[Docket No. 2003-SW-17-AD; Amendment 39-13215; AD 2003-08-51]

Airworthiness Directives; MD Helicopters, Inc. Model 369A, D, E, H, HE, HM, HS, F, and FF Helicopters; Correction

Airworthiness Directives; MD Helicopters, Inc. Model 369A, D, E, H, HE, HM, HS, F, and FF Helicopters

2003-08-51 MD Helicopters, Inc.: Amendment 39-13215. Docket No. 2003-SW-17-AD.

Figure 1. Tail Rotor Blade Assembly Inspection

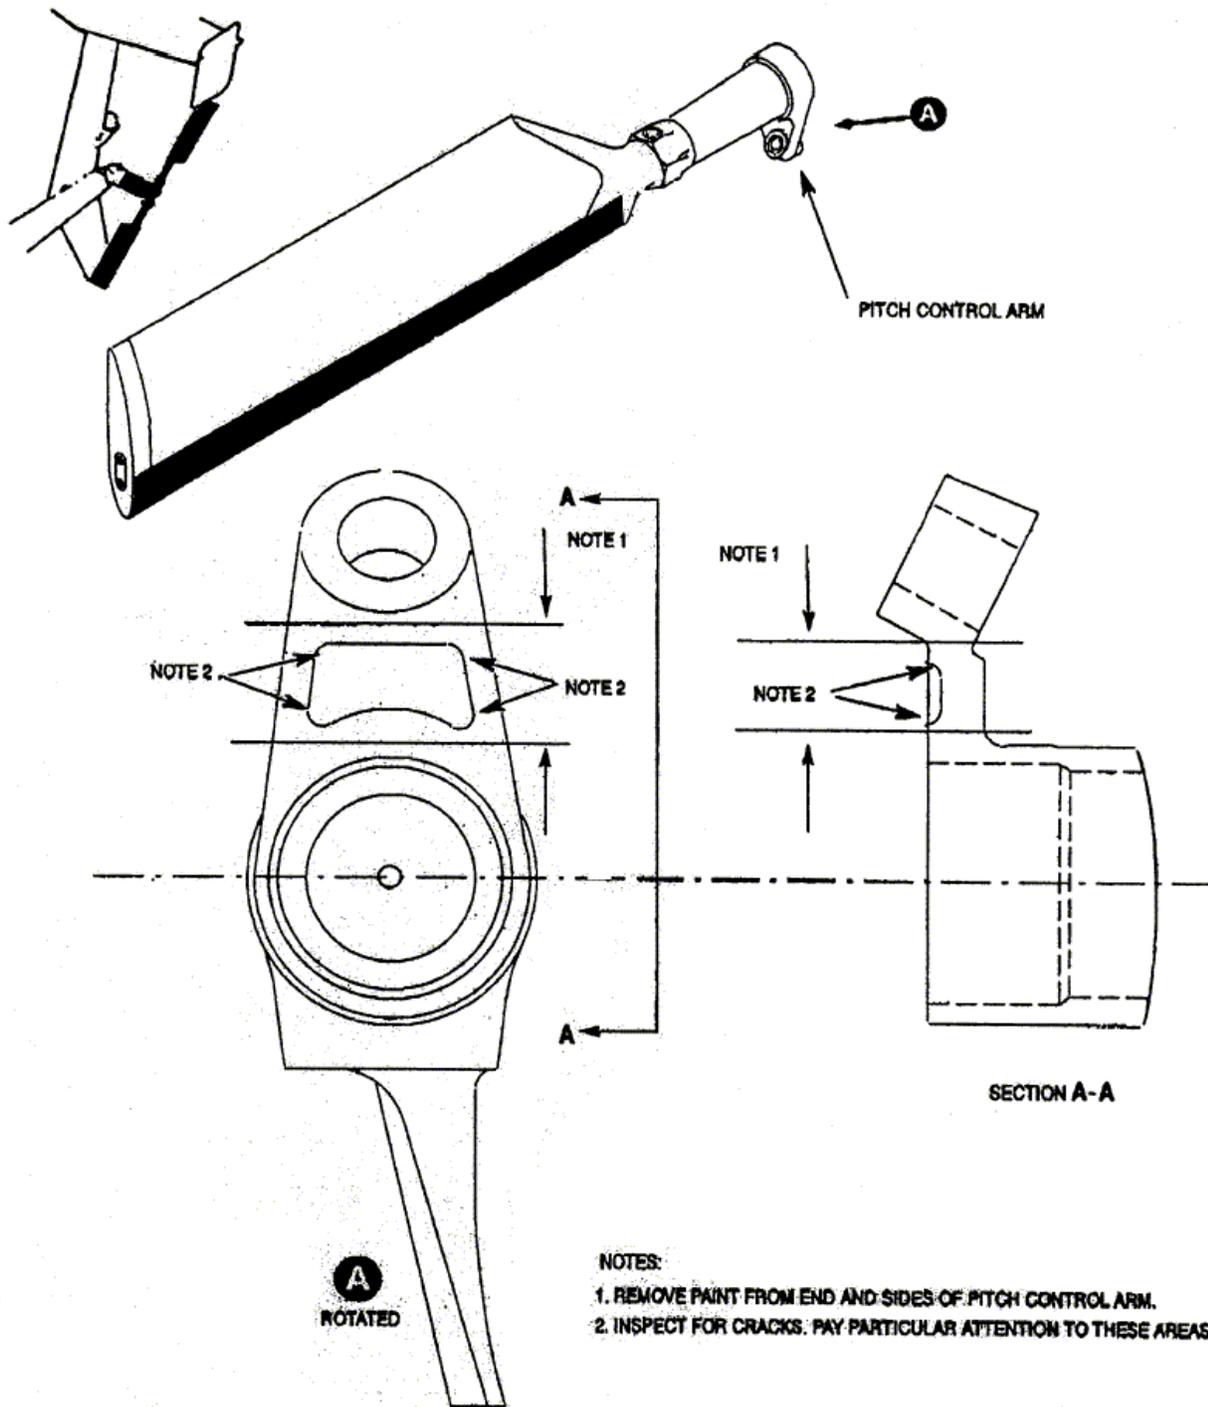
(b) Before further flight, perform a one-time visual inspection of each pitch horn for a crack or corrosion in the area indicated by Note 2 in Figure 1 of this AD. Paint removal in accordance with Note 1 of Figure 1 of this AD is not required for the visual inspection.

(d) For helicopters with a tail rotor blade installed that has more than 700 hours TIS, a one-time special flight permit to fly it to a repair facility may be issued only upon completion of an eddy current surface scan of each affected pitch horn (see Figure 1 of this AD). Paint removal in accordance with Note 1 of the Figure 1 of this AD IS required for the surface scan. If a crack is found, remove the tail rotor blade and replace it with an airworthy tail rotor blade before further flight.
